Access Compliance Report Public Rights-of-Way (Curb Ramps)

Main Street: FLINTRIDGE_AVE		Cross Street: ROANOKE_DR		Location:	S
ADA ID: RPRK211108124919	Ramp Type: Type 4 - Parallel	Initial Pass/Fail: Fail	Overall Compliance: No	Severity Score:	16
Codes/Mitigation Info/Possible Solution			Field Measurements/Component Compliance

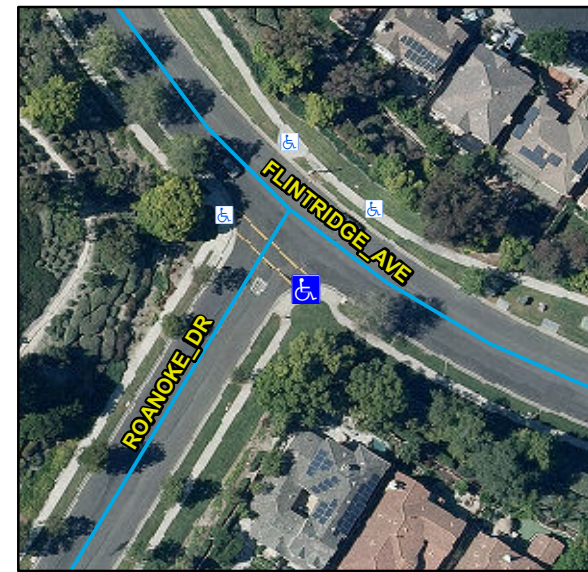
Compliance	Description	Data	Compliance	Description	Data
N/A	Ramp Length LT (in)	108	N/A	Ramp Length RT (in)	106
Yes	Ramp Width LT (in)	90	Yes	Ramp Width RT (in)	90
Yes	Ramp Run Slope LT (%)	3.7	No	Ramp Run Slope RT (%)	11.8
Yes	Ramp Cross Slope LT (%)	2	Yes	Ramp Cross Slope RT (%)	2
N/A	Landing Present	N/A	N/A	DWS Provided	N/A
N/A	Landing Length (in)	N/A	N/A	DWS Contrast	N/A
N/A	Landing Width (in)	N/A	N/A	DWS Length (in)	N/A
N/A	Landing Run Slope (%)	N/A	N/A	DWS Full Width	N/A
N/A	Landing Cross Slope (%)	N/A		DWS Offset Type	N/A
N/A	Landing Movement Obstructed?	N/A	N/A	DWS Offset Left (in)	N/A
	Landing Movement Type	N/A	N/A	DWS Offset Right (in)	N/A
N/A	Landing Shared	N/A			
N/A	Clear Space	Yes			
N/A	Clear Space To Crosswalk (in)	N/A			
N/A	Marked Crosswalk 1	No	N/A	Marked Crosswalk 2	Yes
	Crossing 1 Direction	NE		Crossing 2 Direction	NW
	Marked Crosswalk 1 Width (in)	N/A		Marked Crosswalk 2 Width (in)	144

Remove & Replace Curb Ramp With Two New Directional Ramps or Equivalent.
